TAHMOOR SOUTH COAL PROJECT GROUNDWATER ASSESSMENT INDEPENDENT REVIEW (STAGE 1)

Prepared for:	NSW Department of Planning and Environment	29 May 2019
--------------------------	---	--------------------

This report summarises the outcomes of an independent peer review of the Tahmoor South Coal Project hydrogeological and groundwater modelling assessment conducted by HydroSimulations (2018).

Figure 2 - Thirlmere Lakes longitudinal section (after HEC 2018, Figure 29)

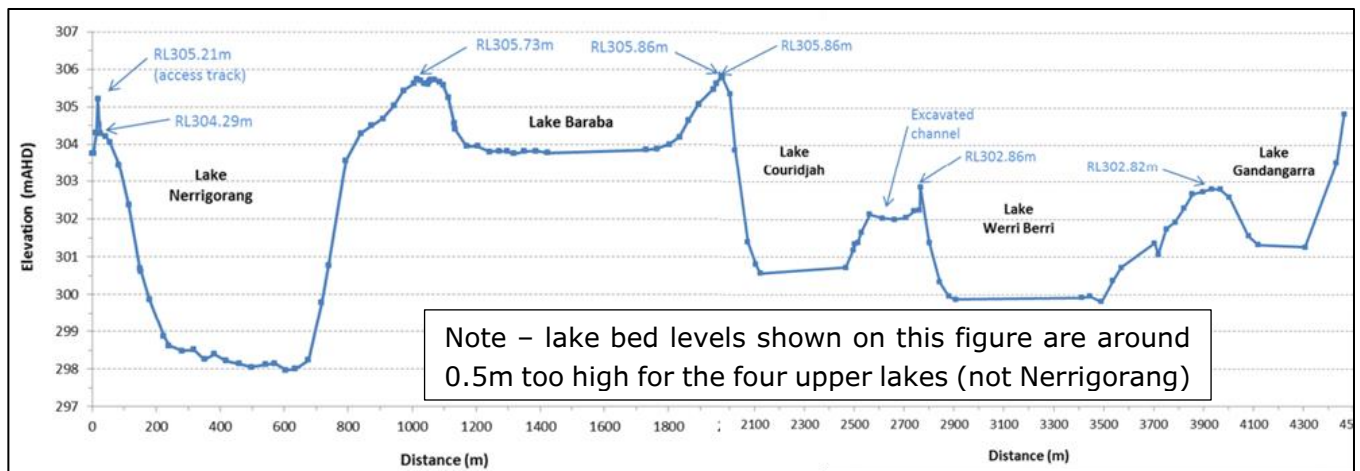
There is a longitudinal section for the lakes (Figure 2), which identifies the bed and crest/overflow levels for the Thirlmere Lakes. There is also data available from four monitoring bores drilled in the Thirlmere Lakes area since 2011 (OEH 2016). The time series data are presented in Figure 3-16 (and Appendix H) of the groundwater assessment (HS 2018), which notes that these are for 'post-mining' conditions only.

The data indicates that alluvial groundwater levels in GW75409/1 vary around 299-301 mAHD, consistently about 2 metres below the adjacent lake level at Lake Couridjah (nearest to Tahmoor). Although the groundwater level is often above the bed level of Lake Couridjah of about 300 mAHD (Figure 2), the lake level is consistently above the groundwater level, indicating losing lake conditions. The groundwater levels in GW75411 near Lake Gandangarra range through 294-299 mAHD, 4-6 metres below the lake level, also indicating losing conditions and clearly lower than the bed of Lake Gandangarra of about 301

mAHD, although this is less definitive as GW75411 monitors the Hawkesbury Sandstone, not the alluvium. The levels in GW75410 near Lake Nerrigorang, however, range through 297-306 mAHD, compared to its lake levels of around 299.5-301.5 mAHD, indicating variably gaining to losing conditions.

Given the above conceptualisation of mostly losing lake conditions (except for a variably losing/gaining Lake Nerrigorang), it can be argued that an appropriately simple/robust approach has been applied to specifying constant lake levels in the groundwater model to represent typical (median) operational conditions (i.e. rather than transient/dynamic lake levels). The model performance adequately represents these groundwater levels in terms of the losing condition of most lakes, but does not perform as well for the variably losing-gaining Lake Nerrigorang, especially as that modelled constant lake level of 301 mAHD (HS section 4.4.3) is similar to the modelled groundwater level at GW75410 (HS Appendix H), which does not reflect the more variable measured range (297-306 mAHD). Although performance could be regarded as adequate, the time series matches to measured groundwater levels should be improved, given the importance of the Thirlmere Lakes. It is also recommended that the groundwater modelling report be updated to include some data/graphs on the variation of the wetted lake area with the lake level, with commentary on implications for the scenario settings.

This review identified some issues with the reported levels of the lake beds and overflow points, and their sometimes inconsistent representation in the groundwater model, and, more importantly in the GoldSim water balance model for Thirlmere Lakes, which should be addressed by the amended DA, as discussed below.

HS section 4.4.3 states that the Lake Gandangarra level was set to 304.6 mAHD in the groundwater model (long term 'median' level). This is about 1.8 m higher than the overflow point to Lake Werri Berri (302.82 mAHD). Subsequent discussions confirmed that is a typographical error and the value in the model data set is, in fact, 303 mAHD, which is still 0.18 m above the overflow level. While this means that Lake Gandangarra is effectively kept above full for all the simulations, the way this was implemented in the groundwater model means that it does not overflow (it simply over-estimates leakage from the lake due to the higher driving head). The other two upper lakes that connect with Gandangarra above its overflow (Werri Berri and Couridjah) have levels specified below their overflows. The proposed amended DA refinement of specifying time-varying lake levels consistent with records would adequately address the issue.

The lake bed levels specified in the HS groundwater model were provided by HEC, but have not been listed in either report. Subsequent discussion on this issue identified that the four upper lakes have bed levels around 0.5 metres lower in the model than the levels indicated in the lake long-section (Figure 2 above). The problem is mainly with the figure rather than the model and is presumably partly due to the 2012 LiDAR survey picking up the low lake level rather than the bed level, but this has not been explained in the reports. Several figures in the groundwater and surface water modelling reports also show incorrect bed levels and should be corrected via the amended DA. It is worth noting that the model results are unaffected by this issue, as they are based on the correct lake bed information and a steady 'median' lake level. The proposed specification of time-variable lake levels in the model will probably have a small effect on the rates and volumes of flux exchanges with groundwater.
